Subject: 12 Carson Lane, St Marys - Review of Ventilation Shafts

Document Reference: SYD2021-1160-R002A

Figure 1 – Location of Ventilation Shafts

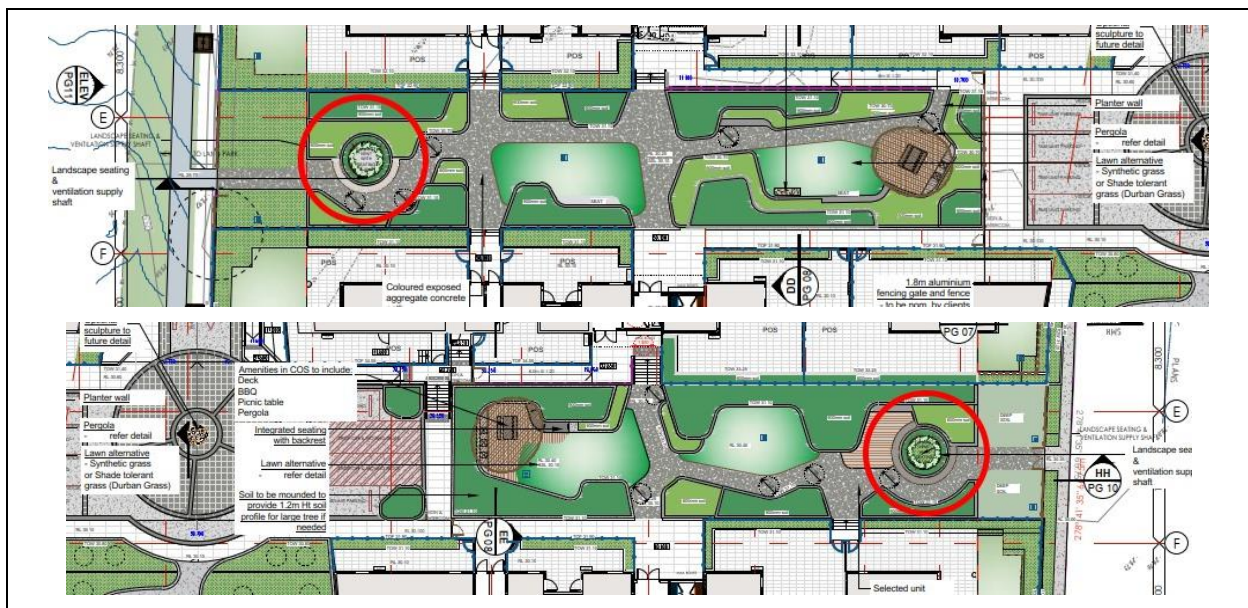
As requested by Council, the following is a preliminary review of the proposed ventilation shafts, as highlighted in Figure 1 within the communal open space areas of the residential development at 12 Carson Lane, St Marys (MOD22/0083).

Typically, based on similar sized residential projects we would expect the following noise control measures to be implemented for the carpark exhaust/supply fans located in the basement:

- Exhaust and supply fans operate with a VSD and CO sensor.
- The fans operate on variable speed and are unlikely to operate at full speed during the night period of between 10pm and 7am.
- Provide acoustic attenuators to the supply and discharge of the fans. The following Table 3 presents the minimum acoustic performance for the attenuators.
- Vibration isolation mounts are to be selected in accordance with manufacturer's recommendations. Where required, incorporate restraining devices to prevent excessive movement of plant, equipment and piping systems. Refer to Table 42 "Selection Guide for Vibration Isolation" of Chapter 47 in ASHRAE Applications Handbook for a guide to isolating vibrating equipment.
